HARTING Product Change Notification

PCN/ 009

Product range: Han-Modular®

Title: Adapter for RJ45 Module

New design

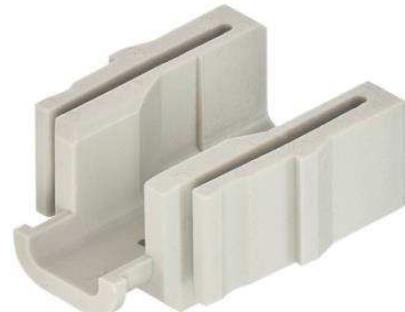
We would like to inform you about a small design change in the RJ45 module adapter (**p/n: 09 14 000 9966**).

The difference between the old and the new design is the additional flange to fix the RJ45 patch cable with a cable tie, as shown in the above pictures.

There will be no change in price or part number; however there will be a new internal revision number change as shown below.

Current p/n: 09 14 000 9966.00

New p/n: 09 14 000 9966.01
